Delegated Report

Prior Approval Extensions Application

Application no:	20230951
Location	61 Milroy Avenue Northfleet Gravesend Kent
Proposal:	Prior approval application for a single storey rear extension with a depth of 6.00 metres, maximum height of 3.20 metres and eaves height of 3.00 metres.
Applicant:	Mr Kamaljit Singh
Site Visit	N/A Desktop Assessment

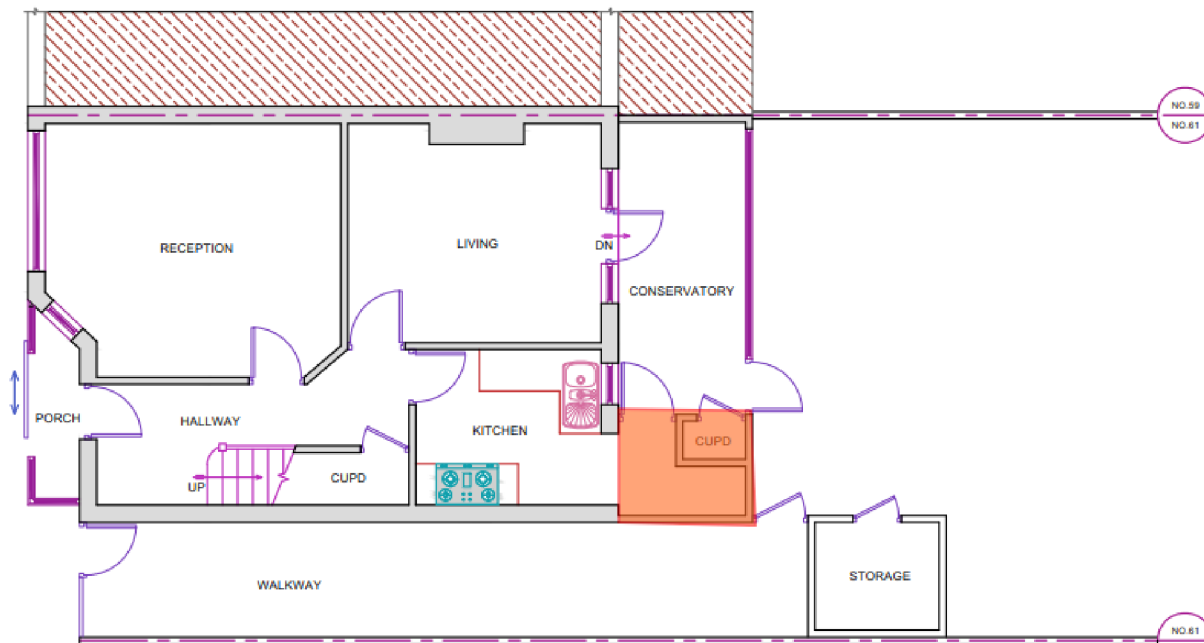
The proposed plans show the proposal would fail to comply with A.1 (j) (iii) as the total enlargement would extend beyond a wall forming a side elevation of the original dwellinghouse and have a width greater than half the width of the original dwelling. For clarity, this refers to the single storey outrigger which is original to the property, which has been shaded on the plan extract below;

Although this element is being demolished, it still forms the original part of the dwelling, which is where the measurement must be taken from.
